APPEAL SUMMARY

LIFE SAFETY CHECKSHEET

Application #: **17-232759-DFS-07-CO**

Street Address:	2835 N KERBY AVE					
Description of Work:	DFS 07 - Applied fireproofing					
The following assumptions were made when reviewing your project:						
Code Edition	Occupancy group	Construction Type	Building Area	Stories	Sprinklers	Alarms
2014 OSSC	I-2 / S-2 / B / H-3	I-A	296,900 SF	5	Yes	Yes

A1 FRAMING PLAN LEVEL 1 - SECTOR A

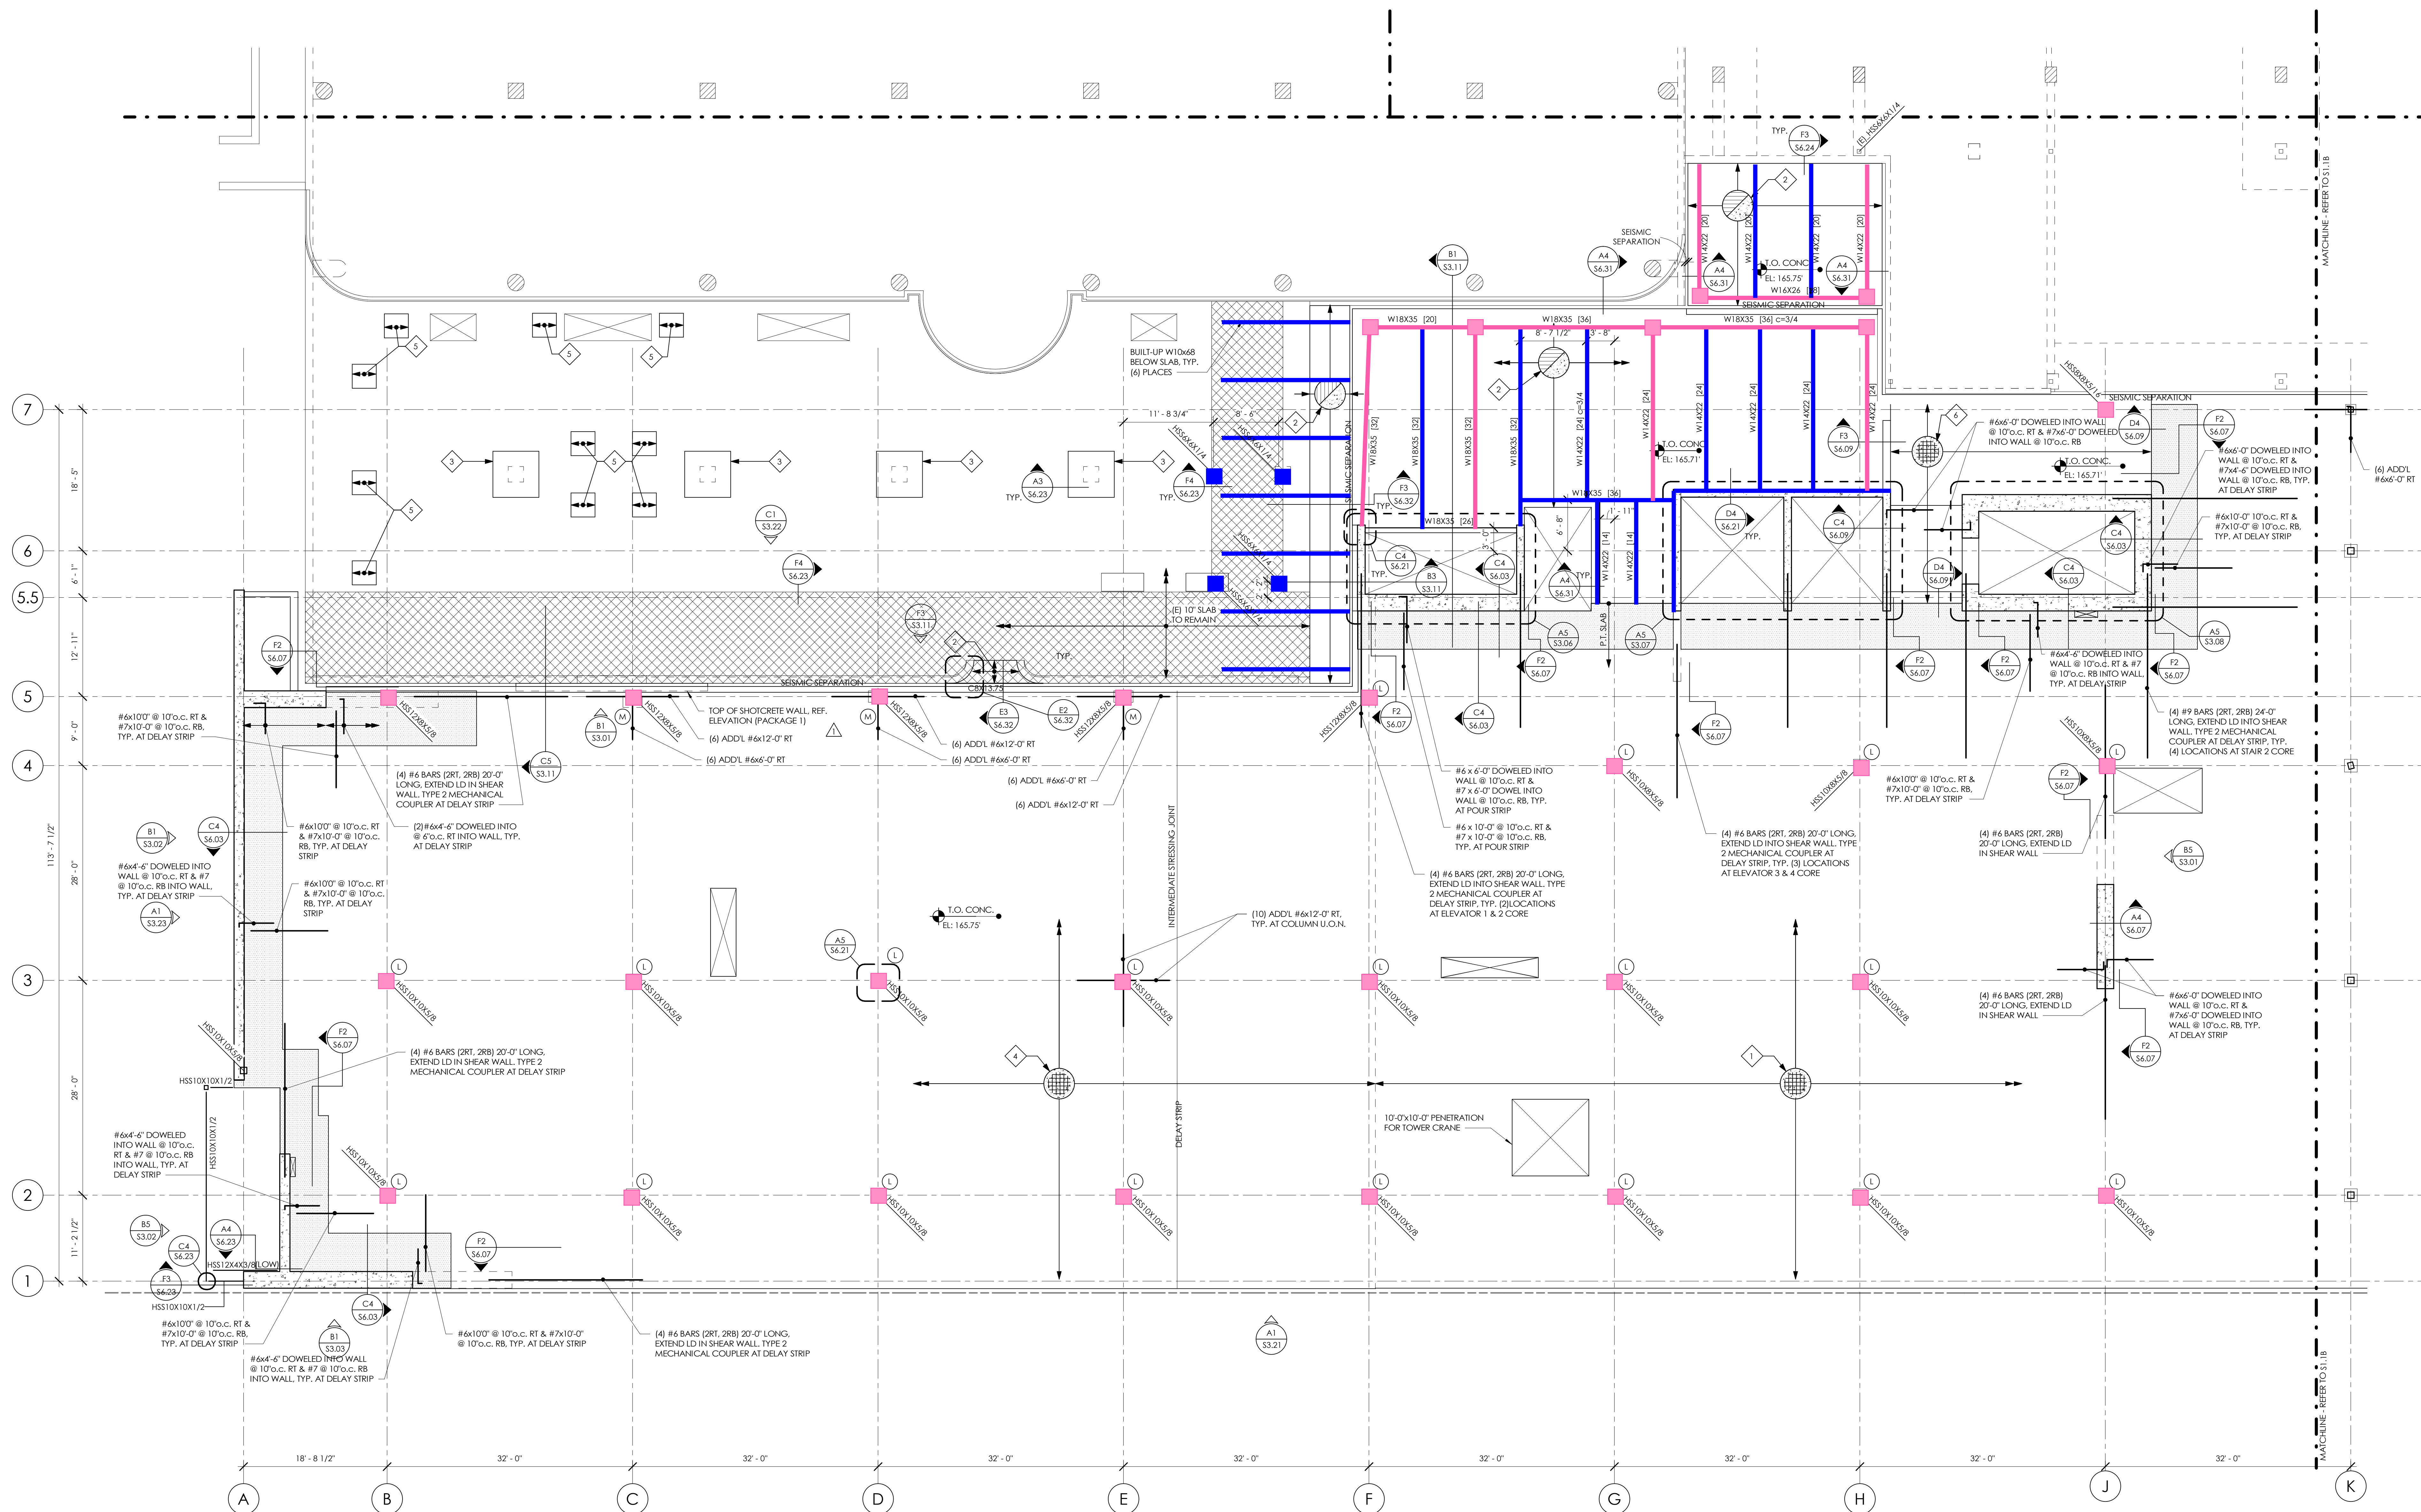
4	Spec Section 078100, S1.1A, S1.4A, S1.4C, S1.5A, S1.5B,	703.2	<u>Spray Applied Fireproofing Assemblies:</u> - Please provide an approved building code appeal for the L5x5x3/8" angle and horizontal HSS 14x6x3/8" as neither shape is defined in UL assembly S721 and we are not aware of any test results for horizontal tube steel. Building code appeals for these situations typically include an analysis or report from a fire protection engineer. - Please indicate a 3-hour fire-resistance rating at the HSS 6x6x1/4 columns on Level 1, as by definition columns are part of the primary structural frame.
---	--	-------	---
